**CHABOT-LAS POSITAS
COMMUNITY COLLEGE DISTRICT
PURCHASING DEPARTMENT**

**Addendum No. 1
INVITATION TO BID No.: B20/21-08
Agriculture Science, Horticulture Facility Project**

AGRICULTURE SCIENCE HORTICULTURE FACILITY

A801

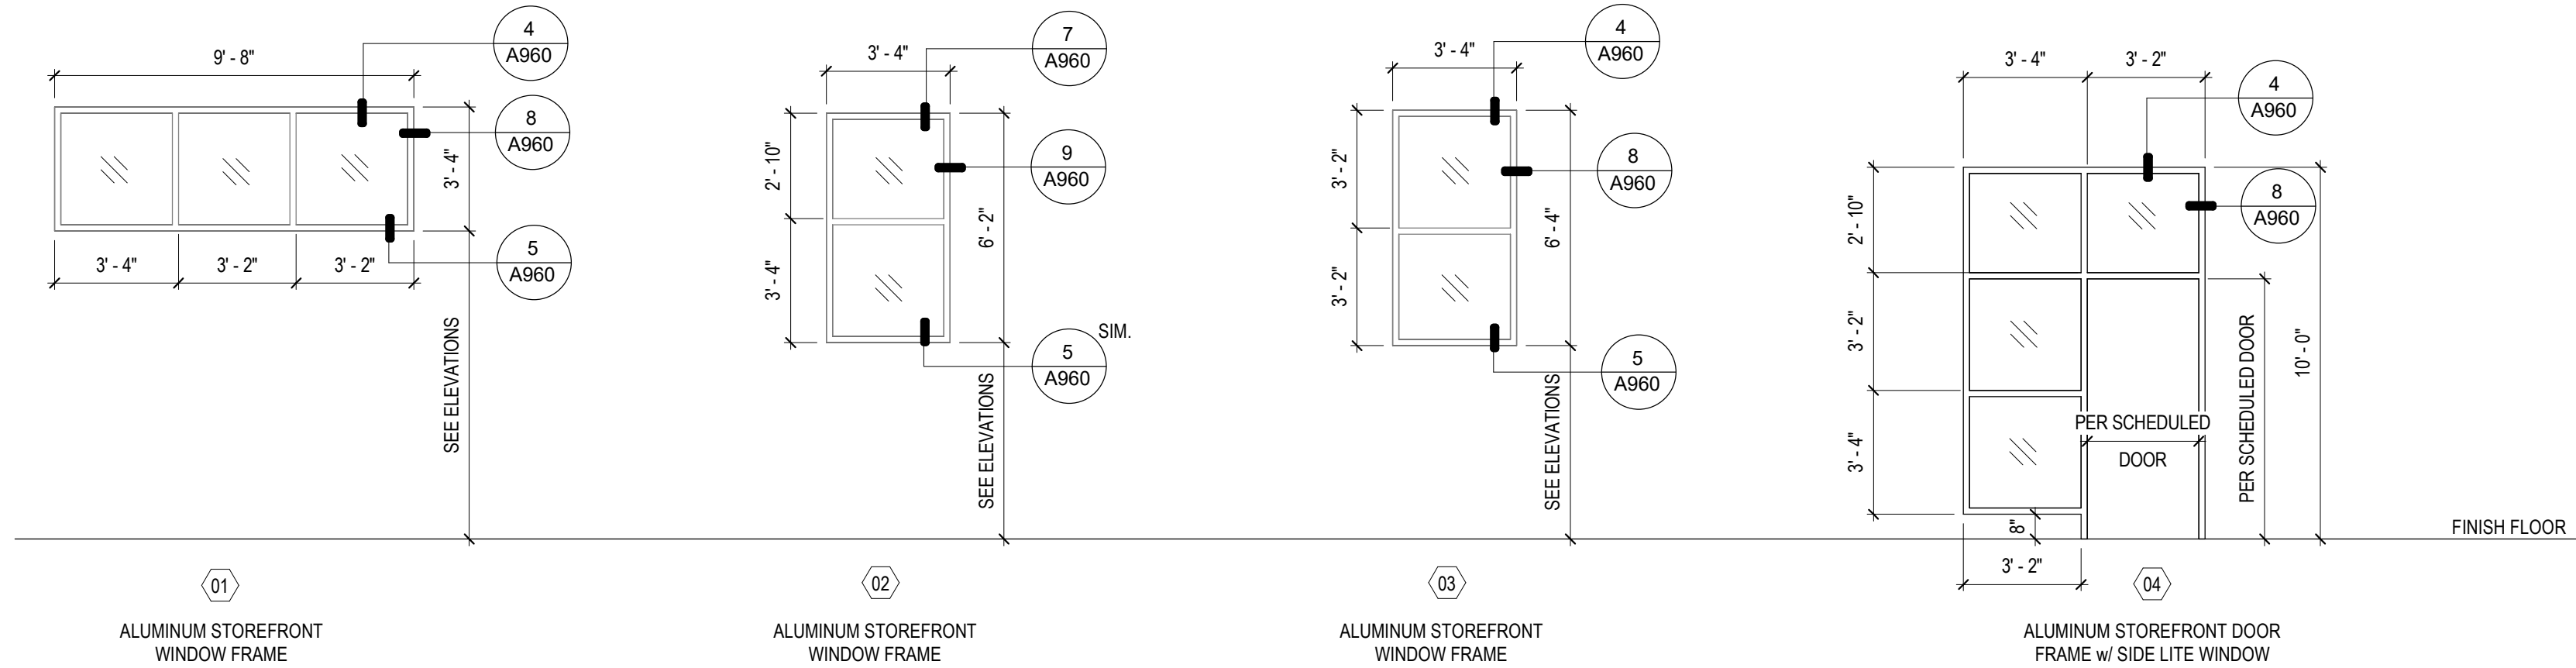
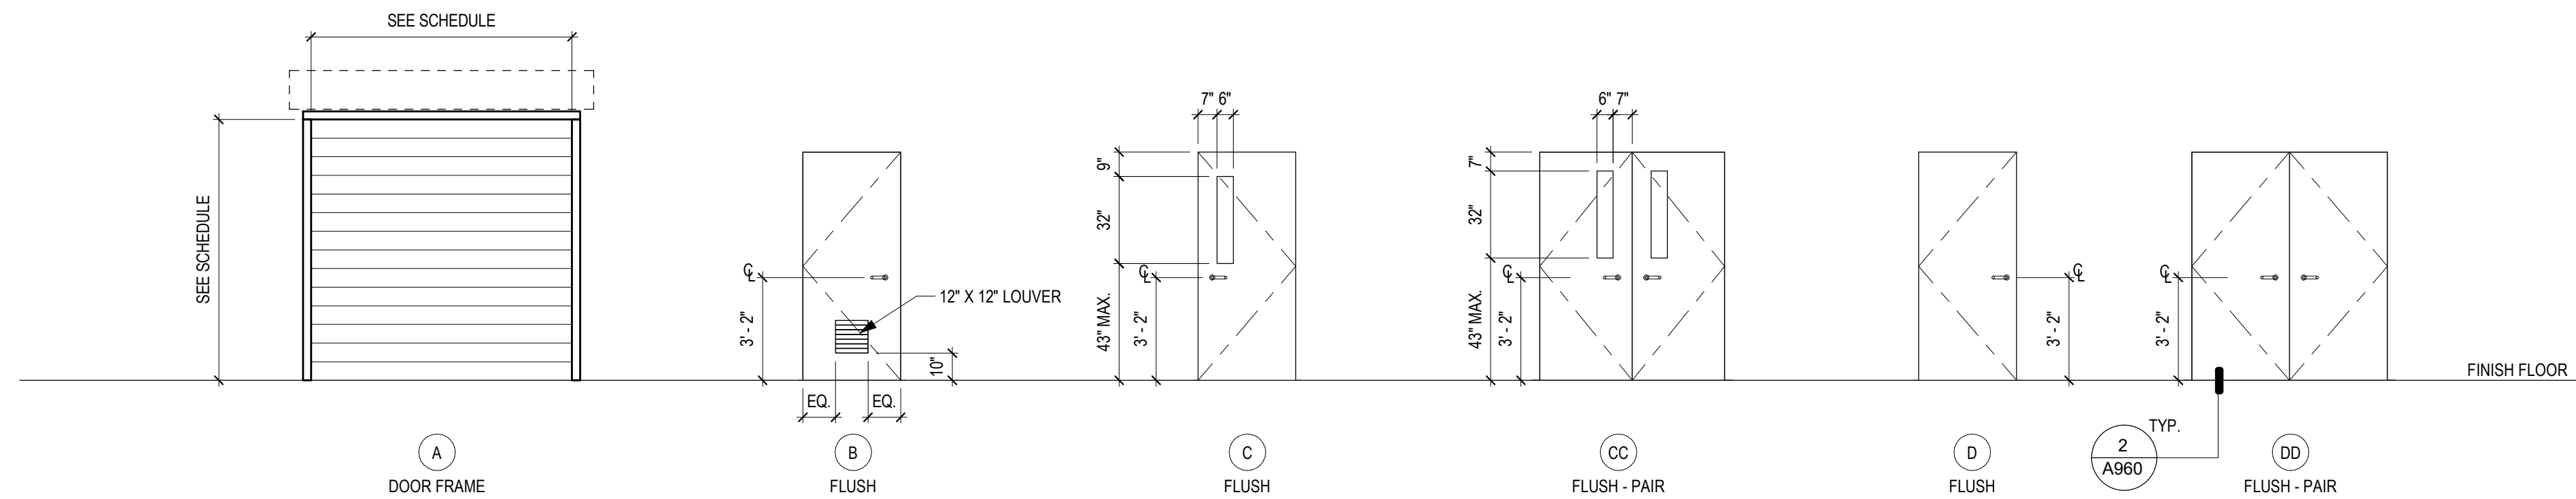
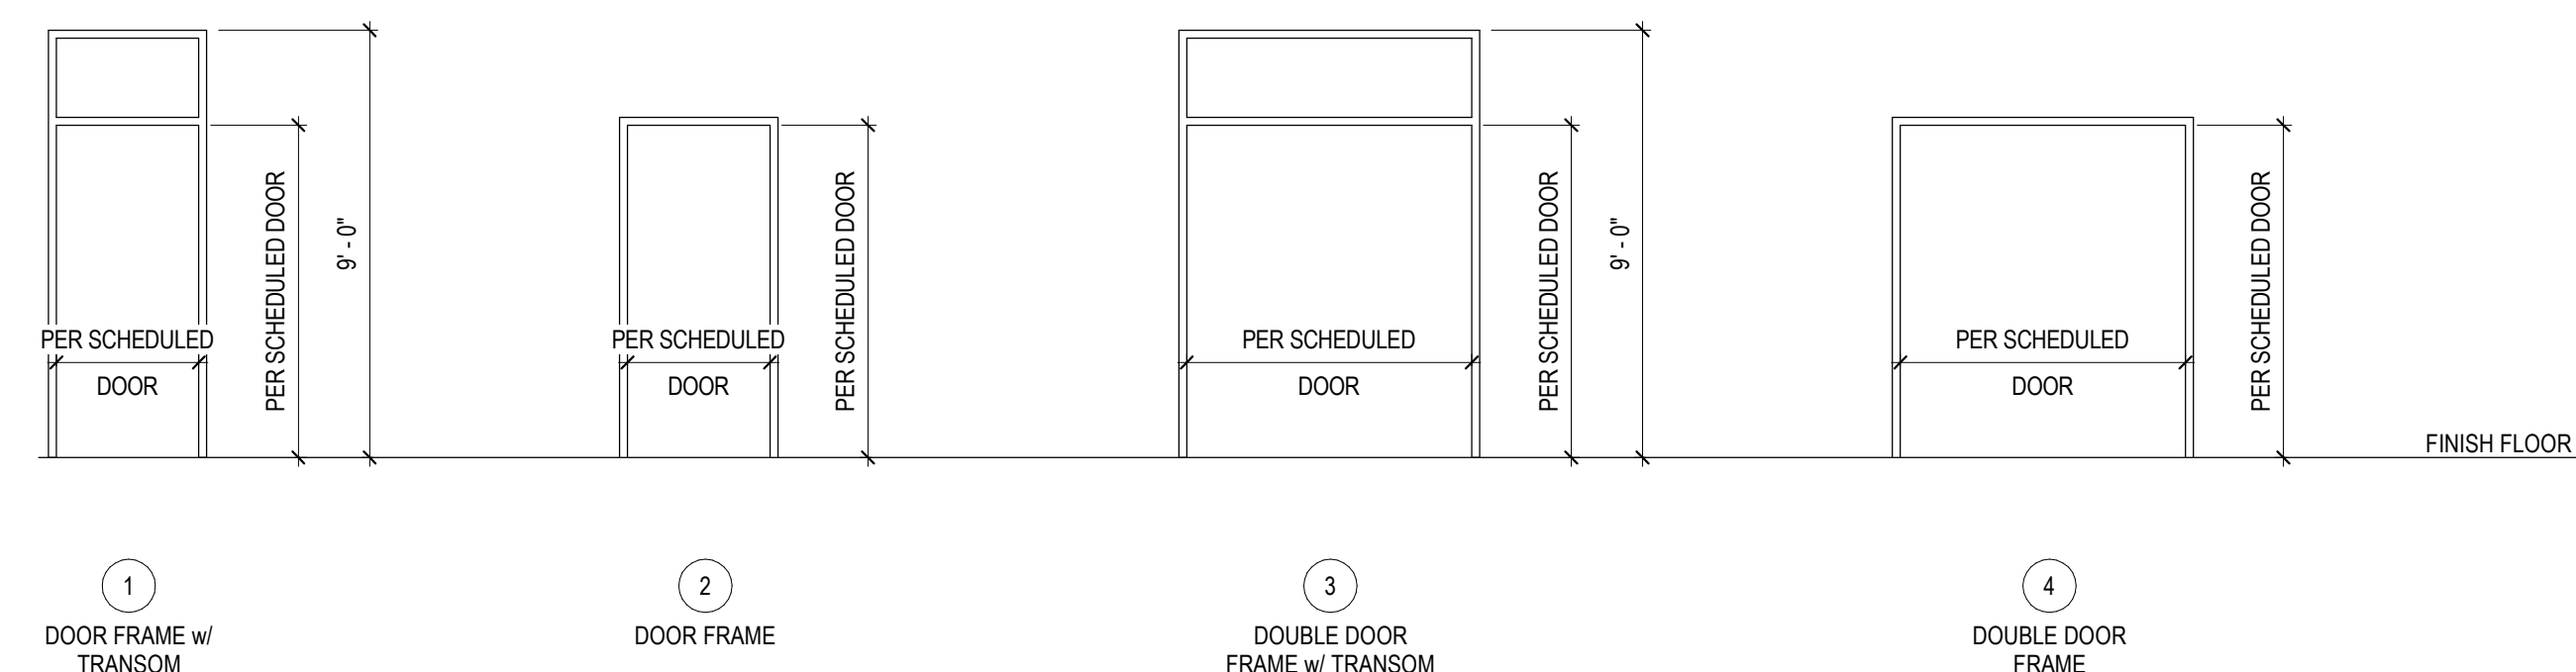
Question No. 2: Sheet A801 – DOOR & WINDOW SCHEDULES & TYPES, is mentioned on G001, however it is missing from Bid Set.

Question No. 5: Please provide Sheet A801

RESPONSE: Enclosed is Sheet A801.

RESPONSE: Enclosed is Sheet A801.
